HYDRONICS - SECOND FLOOR PARTIAL PLAN

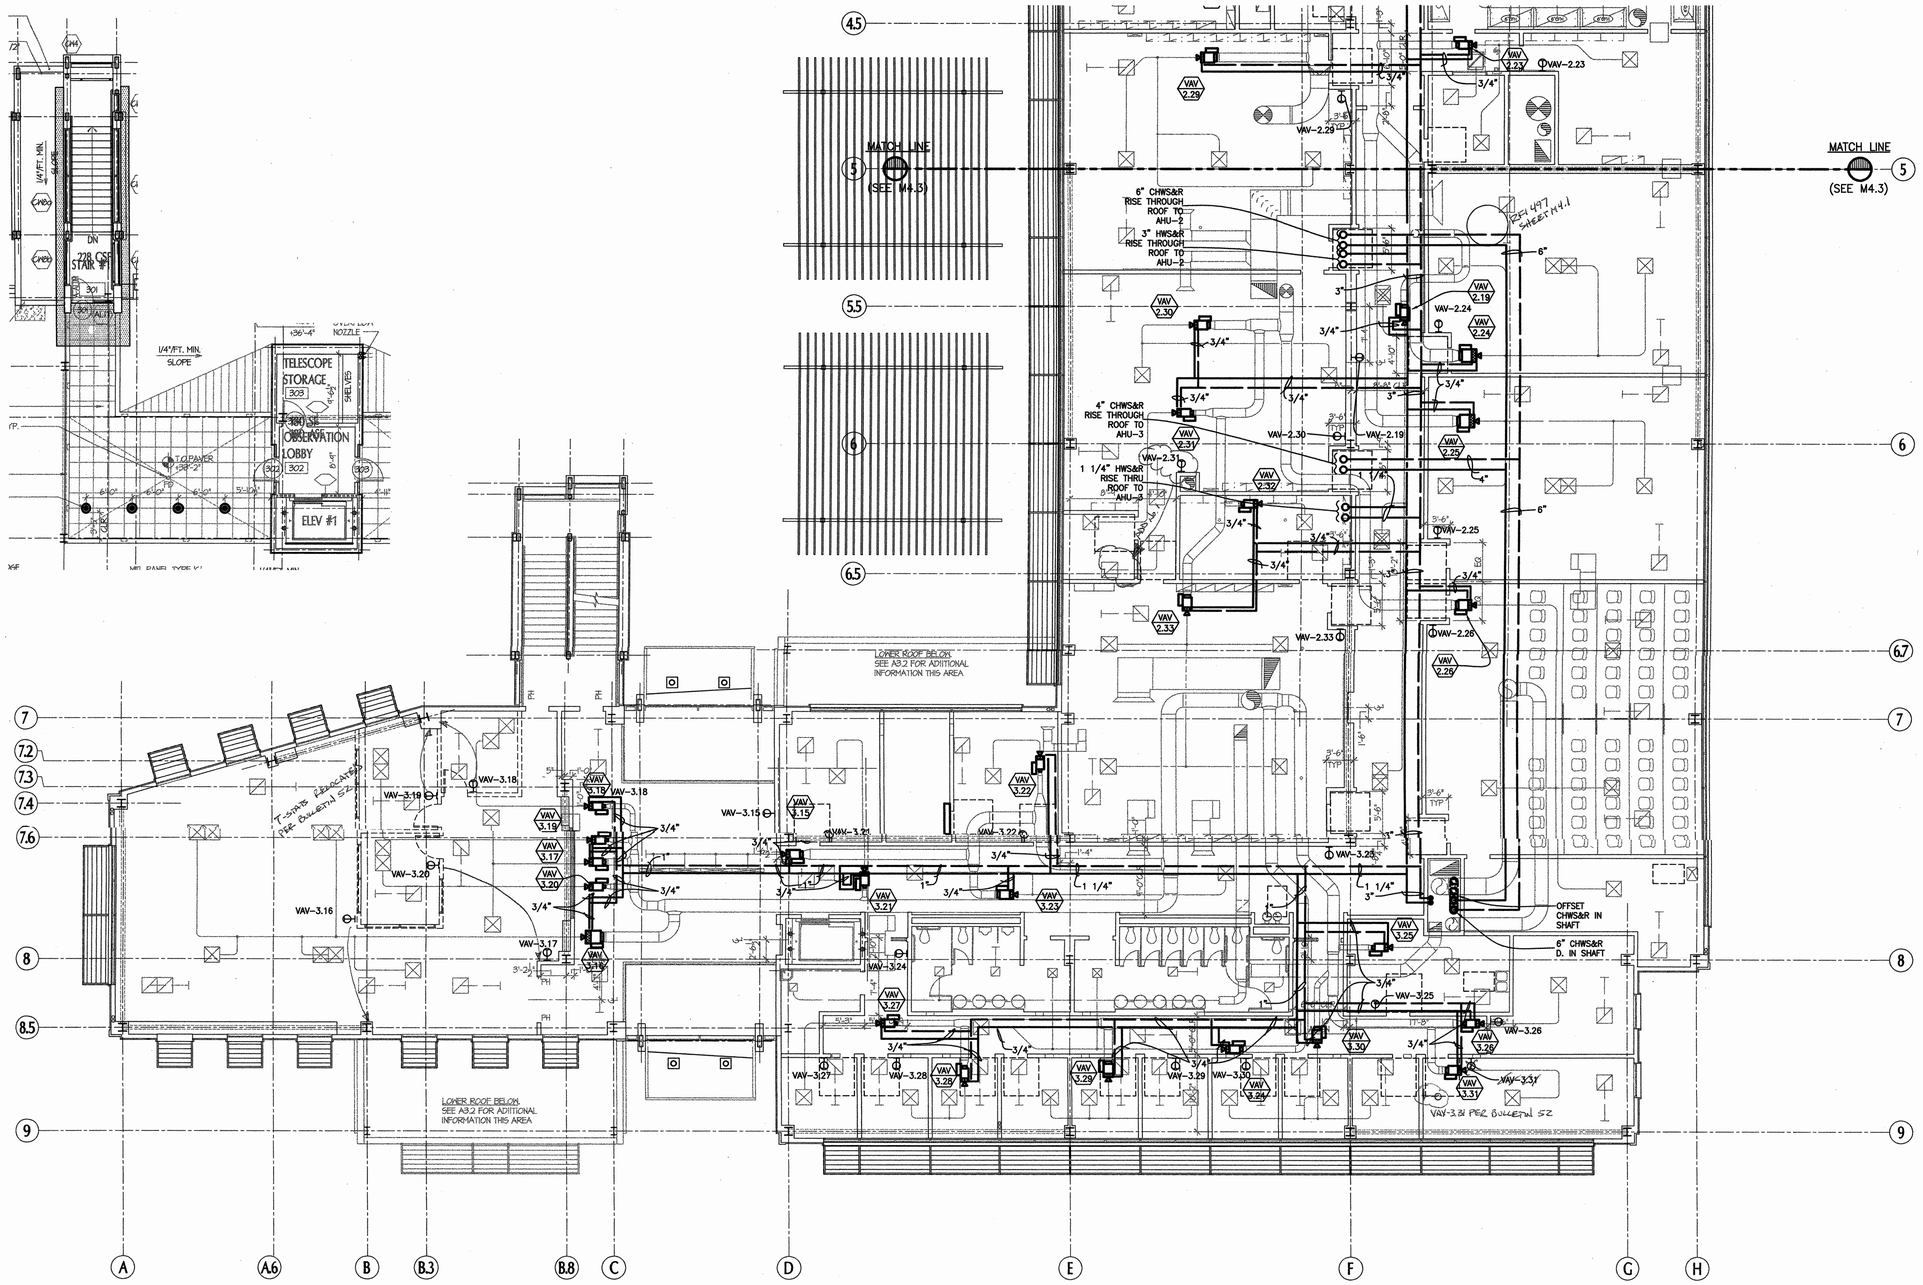
Moved temperature sensor for VAV 2.31 to wall next to interior door in Storage 247 at "Hydronics – Second Floor Partial Plan" 1/M4.4. ADDENDUM No. 1

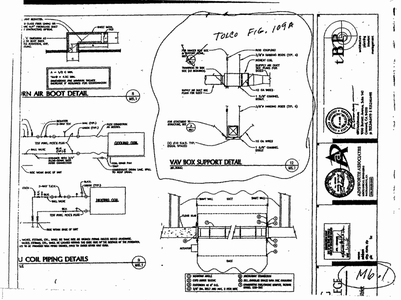
Please note the attached Monterey Mechanical RFI No. 8 regarding the VAV box support details 3 and 12 on M6.1. Please advise.

1. Detail 12 calls for supports consisting of hanger rods and channel strut for all VAV boxes. To help with access to the controls and actuators mounted to the side of the VAV's we propose using the attached detail marked No.5, that uses straps for boxes under 50lbs.(wet). The straps can be hung as not to block access of controls. All boxes over 50lbs. would be supported by Detail 12 as shown on Contract drawing M6.1.
2. Detail 3 shows several options for upper rod inserts for pipe. We would like to use a pre fabricated concrete deck insert Tolco Fig. 109A with 3/8"rod for all VAV boxes over 50 lbs. This insert has been previously approved for use as a pipe insert on this project. See attached sheet.

DASSE Response
1. Use of detail no 9 with mark-ups is structurally acceptable.
2. Use of Tolco concrete insert is structurally acceptable. Guy J 5-31-06

LABRATORY DUCT CONSTRUCTION DETAIL 14 M6.1
NO SCALE

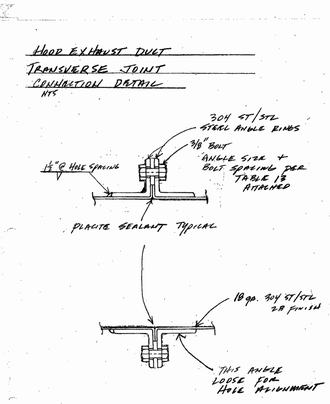
1. Detail 14, drawing M6.1 indicates that the lab hood exhaust duct is to be constructed using 18 gage stainless steel with welded joints. We will need to provide a flanged joint, at a minimum, where the duct attaches to a lab air valve, flex connection to equipment, and at the hoods. No detail has been provided in the contract documents so we propose using the attached "Hood Exhaust Duct Transverse Joint Detail Connection Detail". This is an industrial type detail that is commonly used for heavy gage ductwork. In fact, Monterey Mechanical used this exact joint detail to join the 18 gage ductwork exhausting the 140 fume hoods that was part of the U.S. Geological Survey Facility in Menlo Park. The project fume hoods that was part of the U.S. Geological Survey Facility in Menlo Park. The project specified Plastite joint adhesive for all fume duct sealing that included approximately 5000 joints. The Plastite provides a bond almost as permanent as weld. Although, with some effort you can break the seal with a thin saw blade if equipment needs to be replaced, or duct changes are required. Plastite was also used in a spray form to coat the interior of fume ducts, so it performs well when exposed to chemicals.

We would also propose the use of this joint detail in lieu of field welding. Field welds can be prone to deficiencies as the environment can not always be controlled, not to mention the additional issues associated with welding in place. Welding in a shop environment is conducive to the fabrication process, we would shop fabricate the ductwork and ship to the site in the largest sections practical to minimize field joints. We feel that both the Owner and Monterey Mechanical would benefit from the use of this joint, while it is not an inexpensive joint, the flanges add strength to the duct, and allow more flexibility in the installation. See the attached documentation.
